intel® Technical Advisory

TA-668-3

Intel® Server Chassis SR1300 SCSI Hot-Swap Backplane Incorrect Crystal

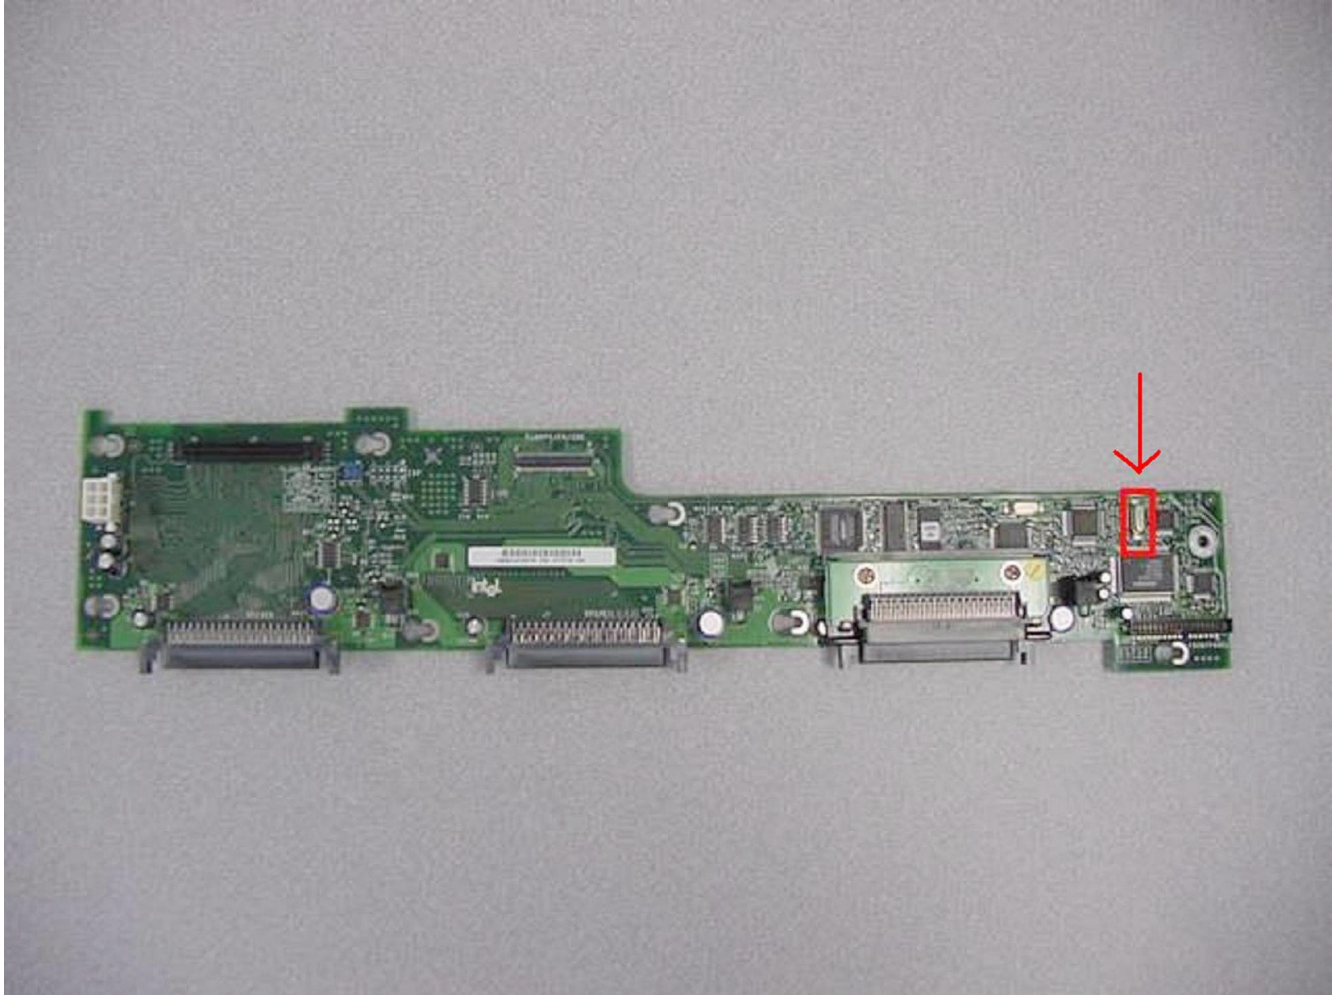
- ❖ Visual inspection is require at this point if customer is using a SAF-TE RAID configuration of the crystal in location Y2
 - Crystal marked with "40.0[N] XXXX ARE affected. The XXXX is a date code related marking

Customers with Intel Server Chassis SR1300 chassis products, spares, and accessory kits with serial number workweeks between 27 and 36 may screen the SCSI Hot-Swap Backplane to determine if it is affected by this issue. To screen the SCSI Hot-Swap Backplane, follow these steps:

1. Remove the lid from the Intel Server Chassis SR1300 (for systems that have already been integrated).
2. Remove the system fan pack from the Intel Server Chassis SR1300 (for systems that have already been integrated).
3. Find the crystal (silver colored) at location Y2 on the SCSI Hot-Swap Backplane (PBA A77570-202). The crystal location is shown in the following two photographs below.
4. Crystals marked with "R400 XXXX" are NOT affected by this issue. Crystals marked with "40.0 [N] XXXX" are affected by this issue. In both cases, the XXXX markings are date code related and may be different, however, these date code markings are not significant to this issue.
